Desert Sands Subdivision

City of El Paso — City Plan Commission — 7/12/2018

SUSU18-00036 — Major Preliminary

PRELIMINARY PLAT

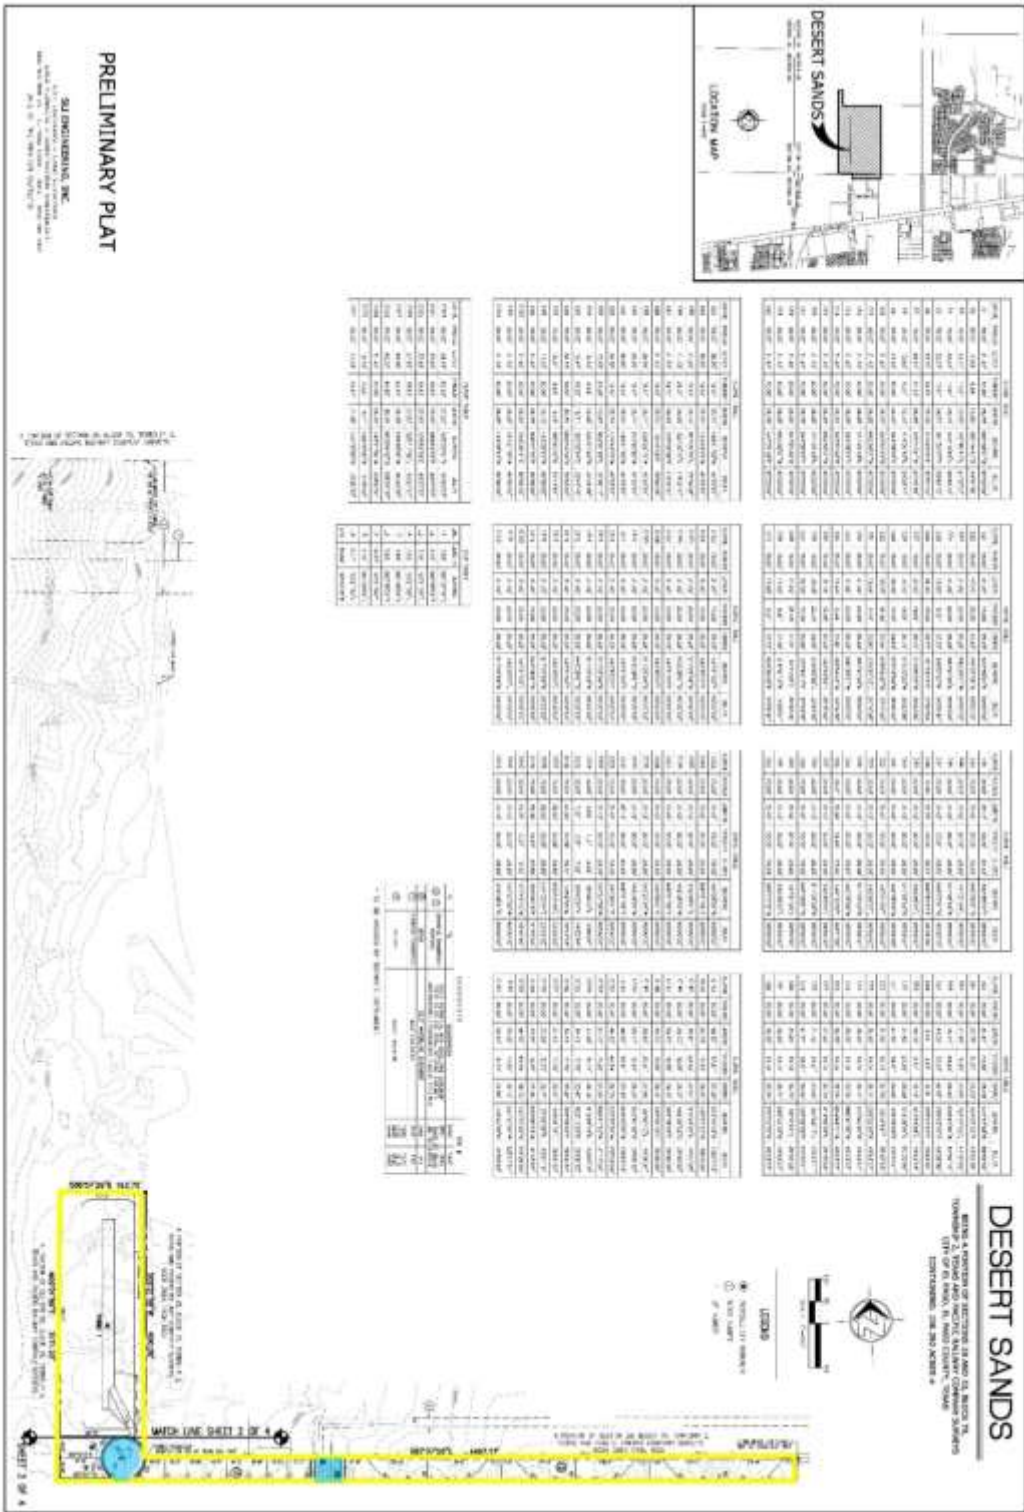
1. Illustrate storm-sewer line routing better in order to clarify where each watershed ultimately belongs respective to phasing.
2. Verify northernmost pond is of adequate capacity for upstream watershed runoff.
3. Update and verify FEMA flood zone FIRM panel information to include 480214-0037B.

Developer will need to coordinate with EPE Operation Departments (Transmission and Distribution) for the proposed improvements or disturbance within the dedicated easement area – Labeled as "Z" on plans.

1. EPWater does not object to this request as long as the future lift station lot is shown and label on plat.
2. All existing PSB easement shall be shown on plat.
3. During the improvement work of the site, the Owner/Developer shall safeguard the existing 16-inch diameter water main and appurtenant structures located within the easement. If any water main facilities are damaged during the improvement work, the Owner/Developer is responsible for the repair costs.

ATTACHMENT 6

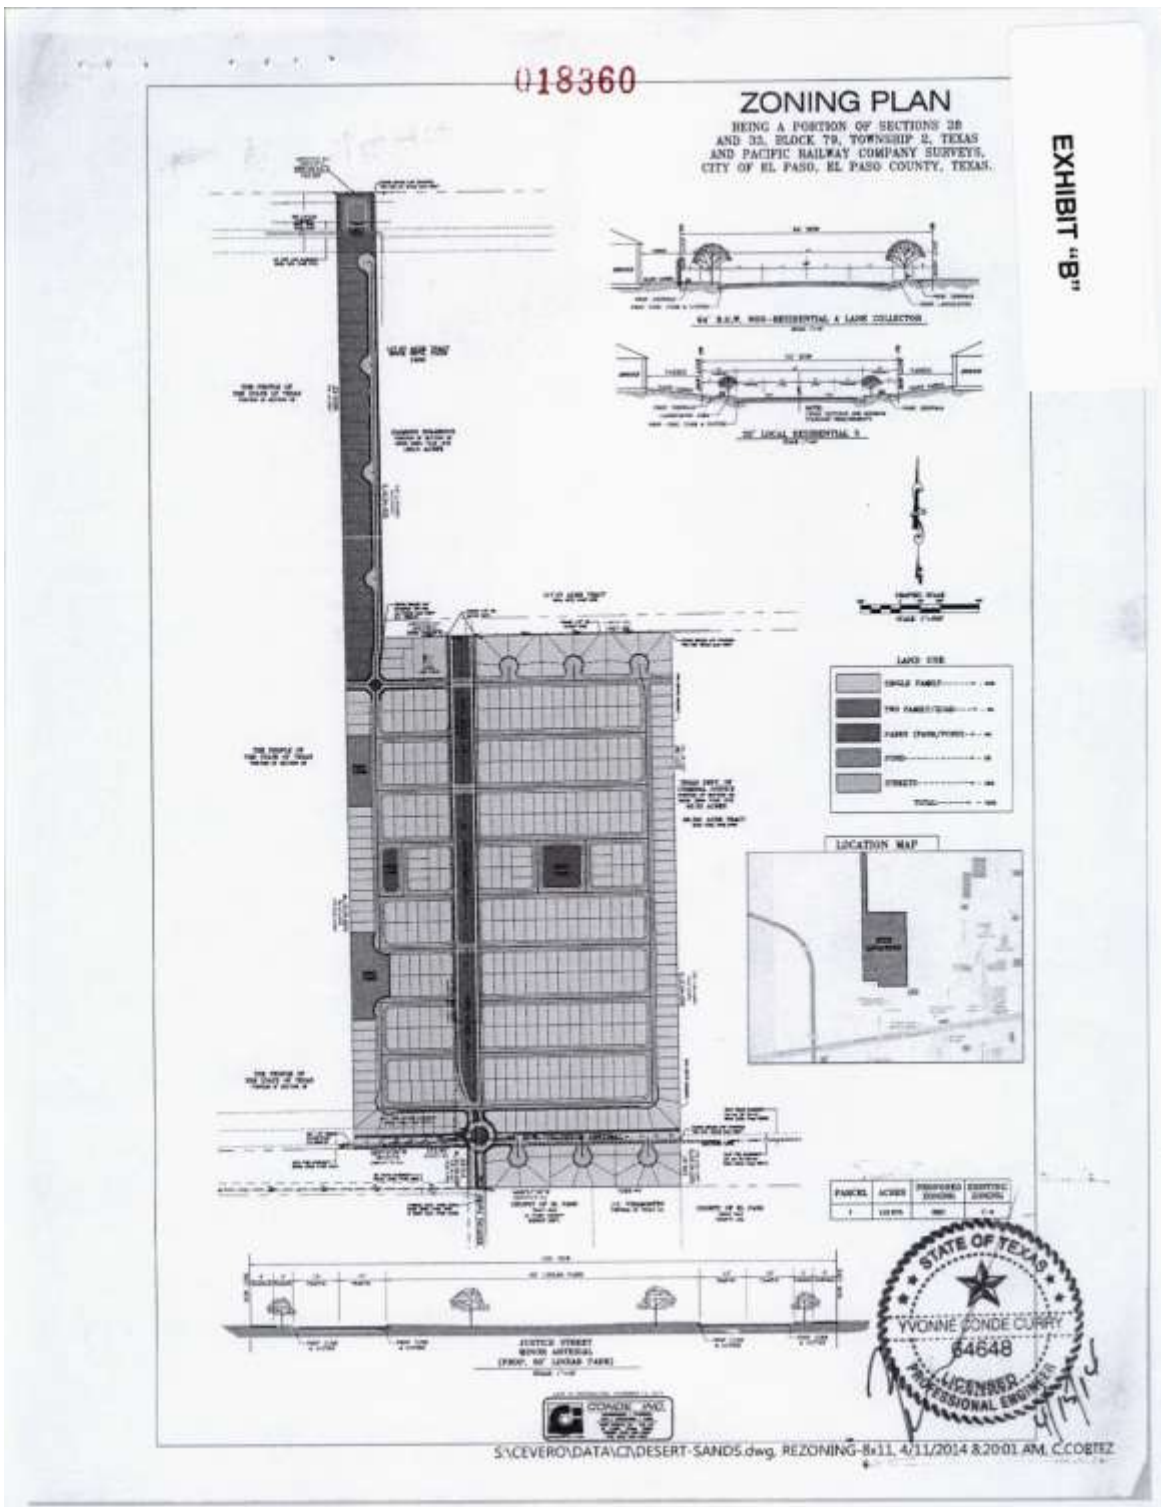
The applicant is requesting a waiver from Section 19.15.080 – Street Length to allow blocks 13, 14, 15, 16, 20, and 21 to reach approximately 850 feet in length instead of the required 800 feet (see map below). According to the waiver request, the block lengths are a result of a master-zoning plan that was approved during the rezoning process as well as Justice Road. Justice Road is an existing street that was kept in its current location to allow access to an adjacent parcel located to the north of the subdivision (see Attachment 6 – Master Zoning Map).
